International Isotopes Inc.
& *International Isotopes Idaho Inc.*

March 2, 2005

Subject: Additional Information to Support Application for Safety Review, I3-101504,
SSD Case 05-04

Figure 1-4. Condition of the 3-inch Teletherapy Capsule following the impact test.

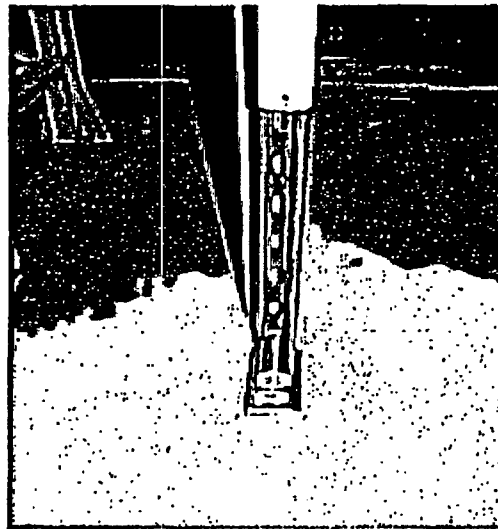
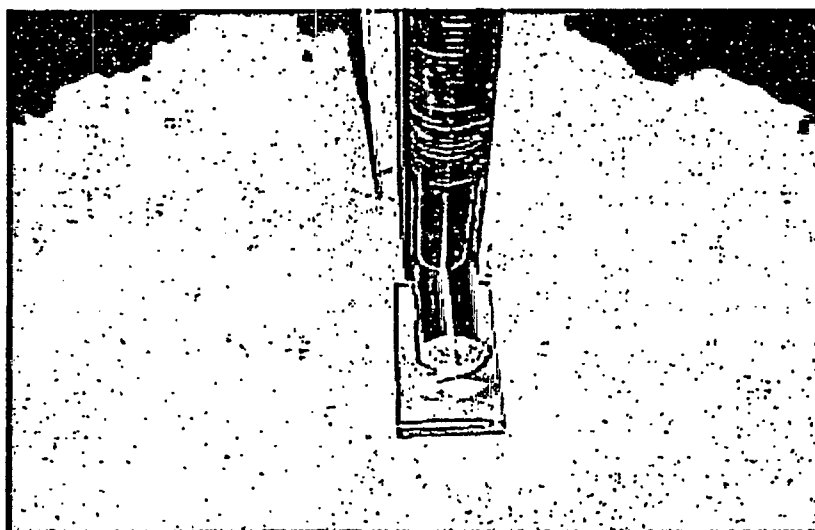
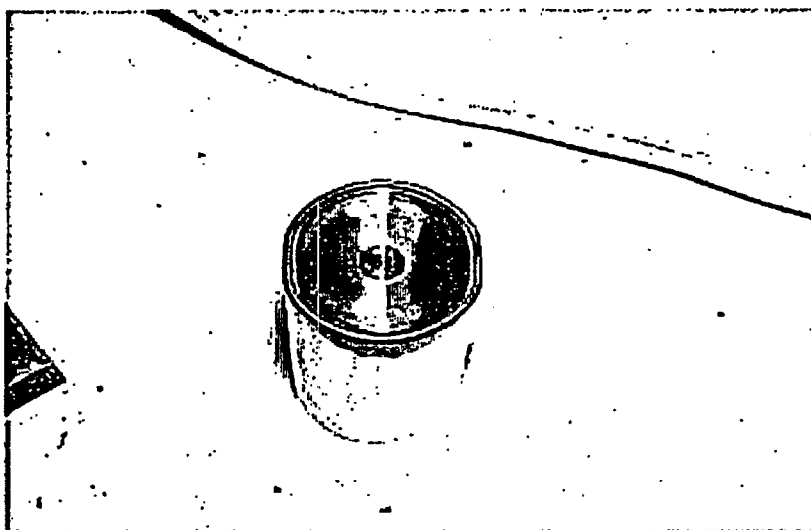
3.2. On page 4 of your application under Manufacturer's Safety Analysis of Sealed Source Review you stated that the INIS-SF-X-YY series design meets the performance classification ANSI 97E53424 per ANSI/HPS N43.6-1997 that is the highest classification for irradiator sources but a Medical Teletherapy source requires a level 5

impact test. Please provide prototype tests for a level 5 impact test of [sic] justify why the current test is acceptable for teletherapy sources.

This was an oversight by I³. Per ANSI/HPS N43.6-1997 the impact test should have been completed at a level 5. This testing has been satisfactorily completed and test results are included (Reference Attachment 3).

Figure 2-5. Condition of the 8-inch Teletherapy Capsule following the bending (load) test.

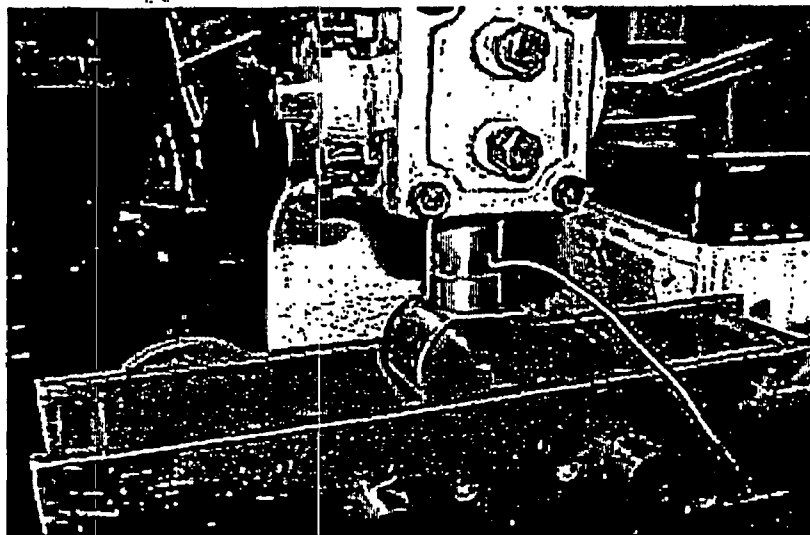
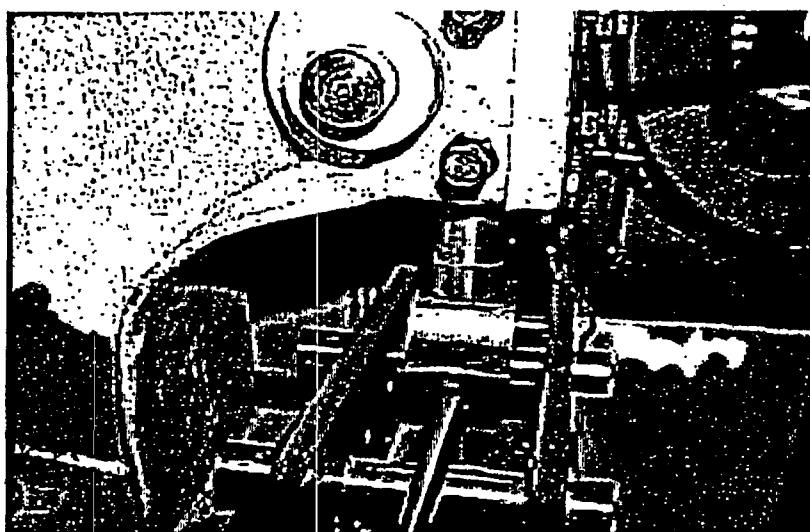
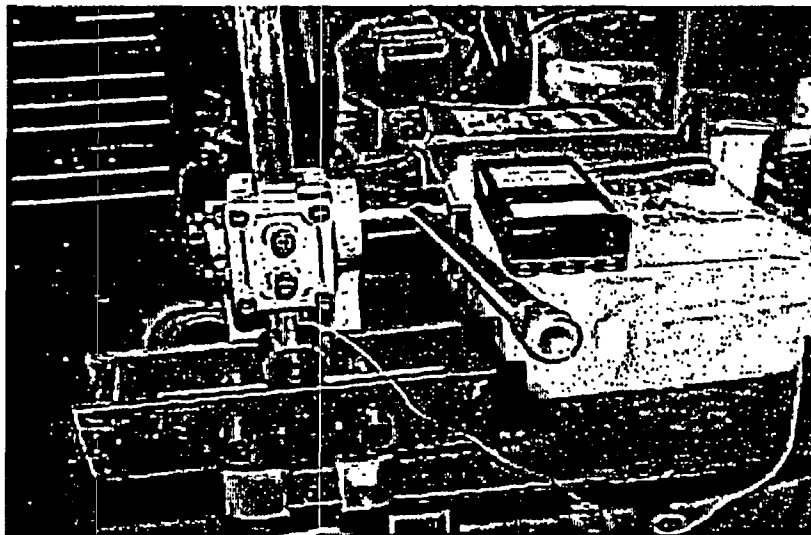
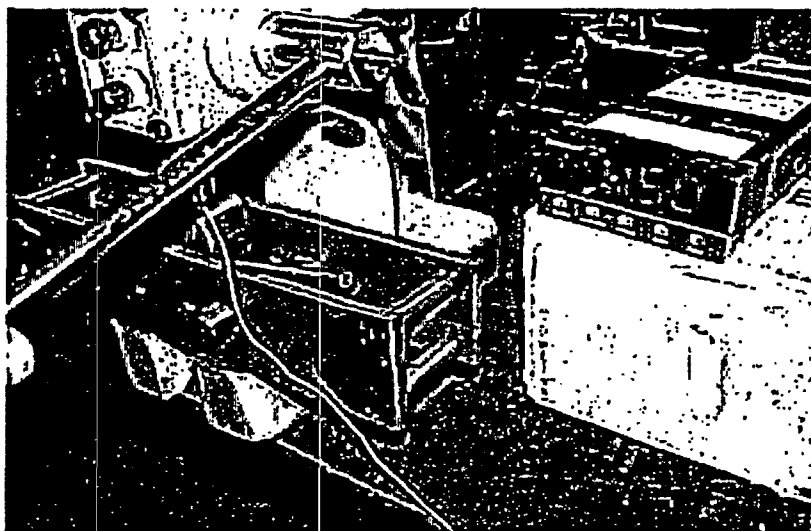
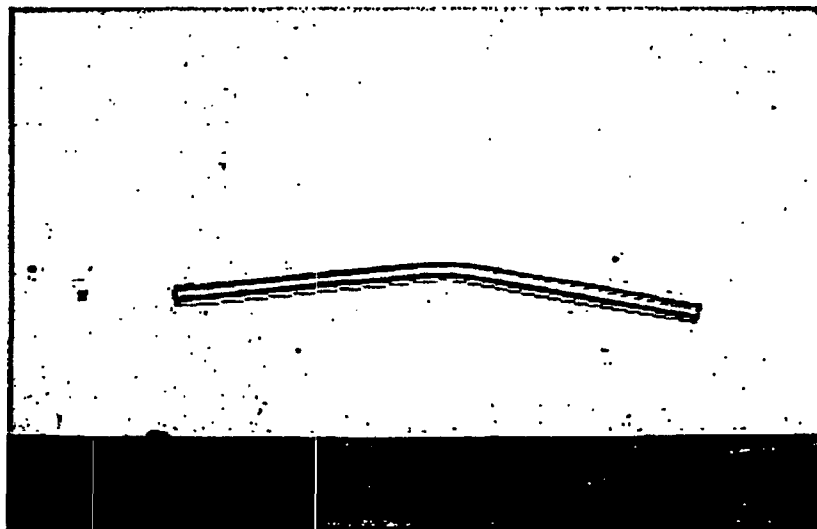
3.3. On page 4 of your application stated that a "static force equal to 2000 N (102 kg) was applied to the Force Cylinder utilizing a press that locked in position for the duration of the test", for the bend test. Please clarify what amount of force was used: 1000 N (102 kg) or 2000 N (204 kg)?

The bend test was performed with a force equal to 1000 N (102 kg). The prototype source was retested at a static force equal to 2000 N (204 kg). Test results are enclosed (Reference Attachment 3).
